Milton Reimers Ranch Park

Master Plan

Adopted by Travis County Commissioners Court on August 14, 2007

Proposed Master Plan

Master Plan Job#P4027-01 08.14.07

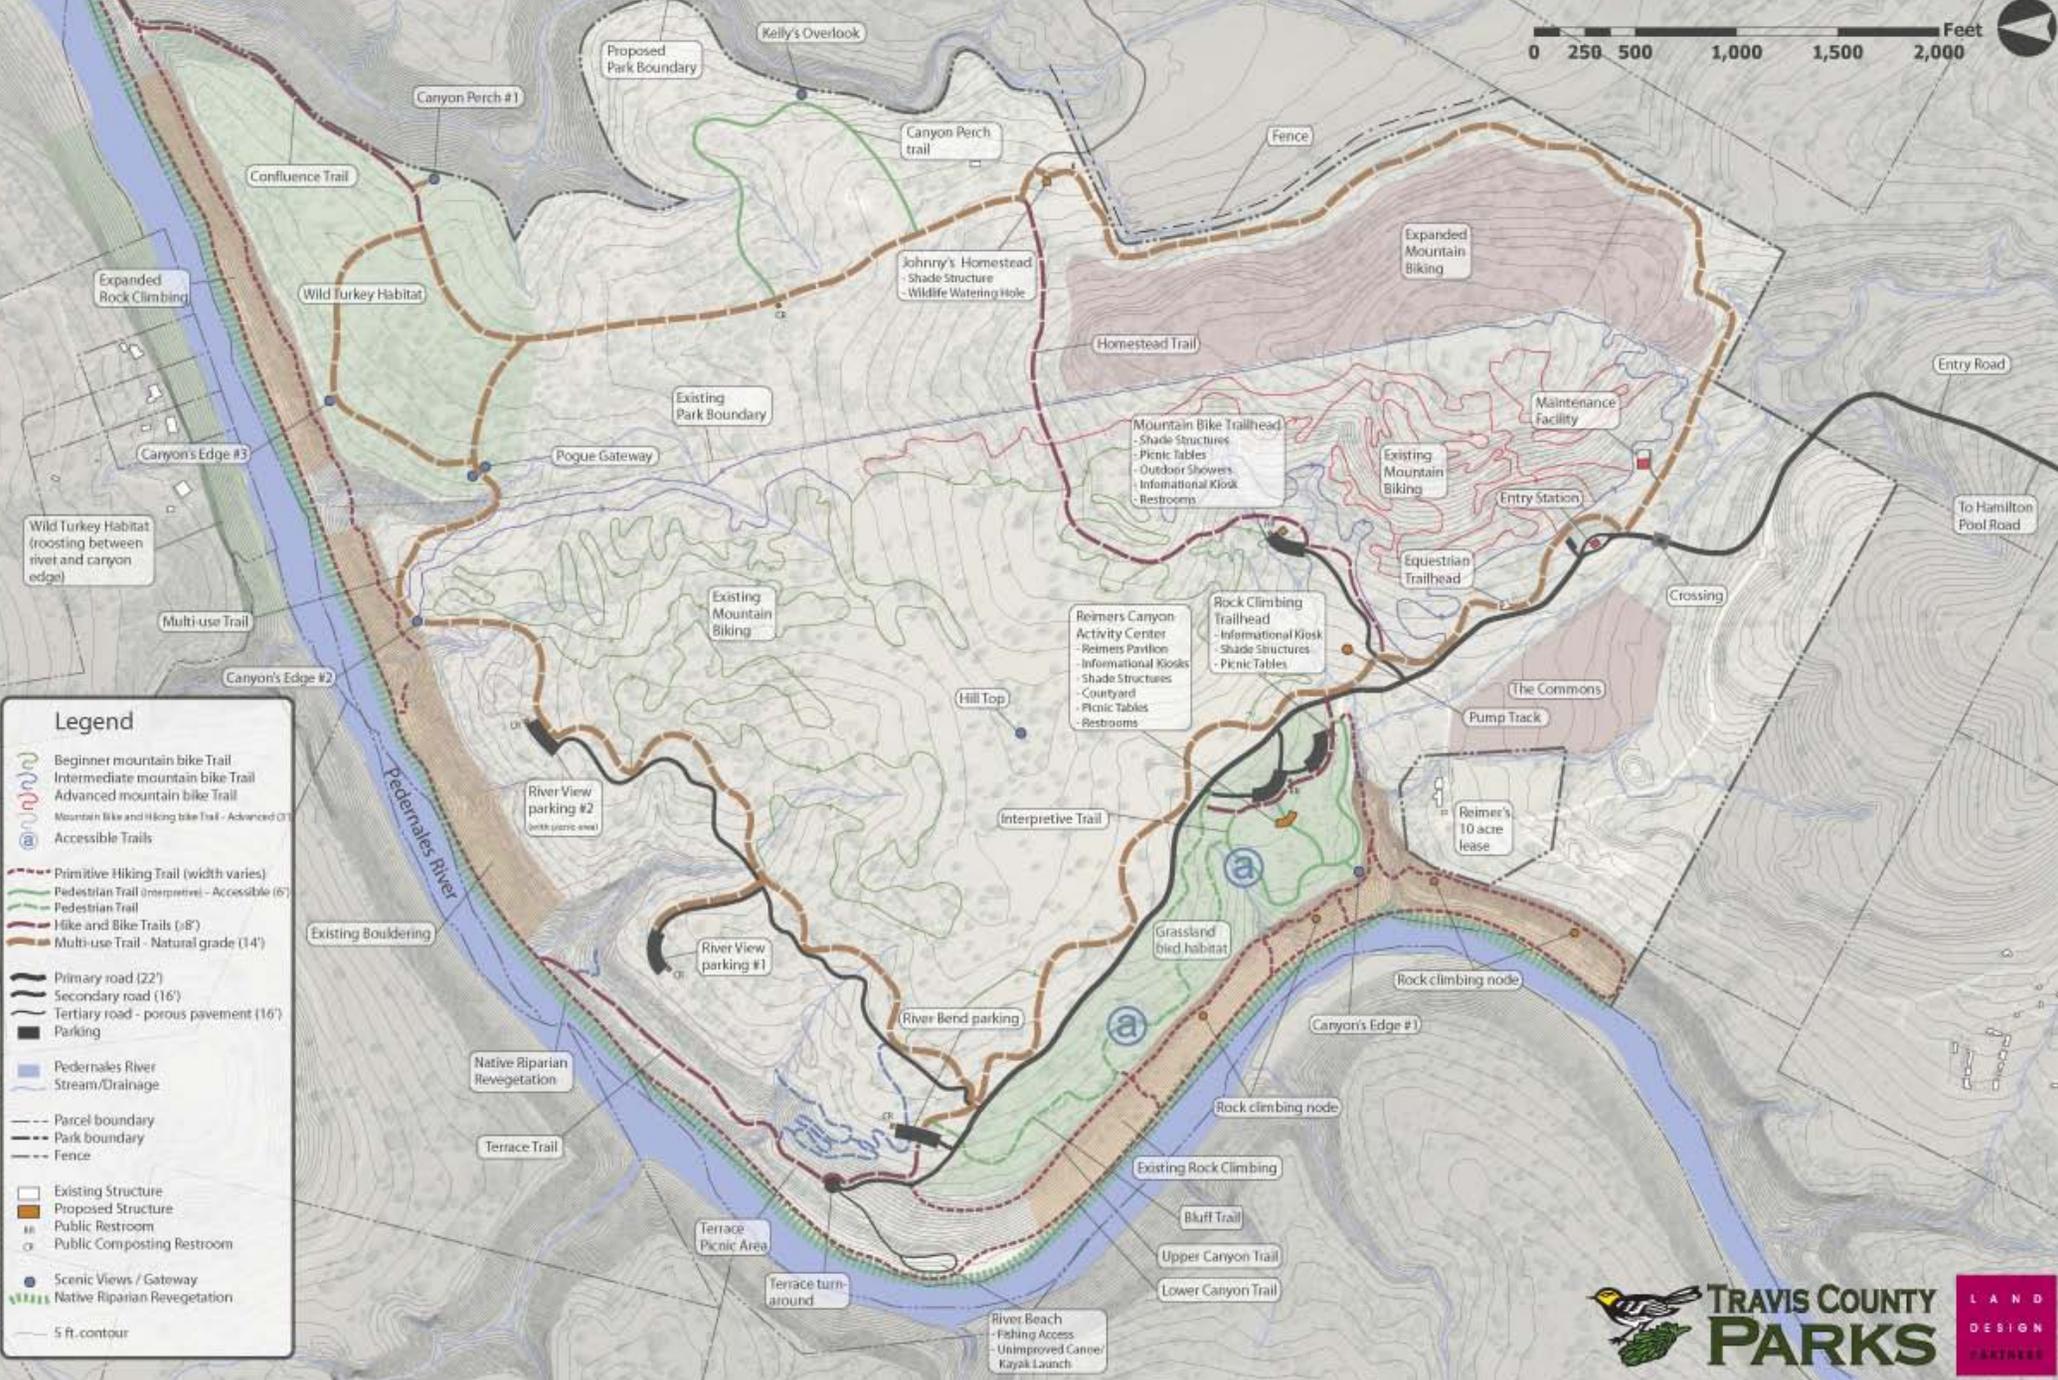
The existing bouldering area is not noted on the master plan drawing. Is this an oversight or a change in use? Not Recorded - 6/5/07

The existing bouldering area has been noted on the plan.
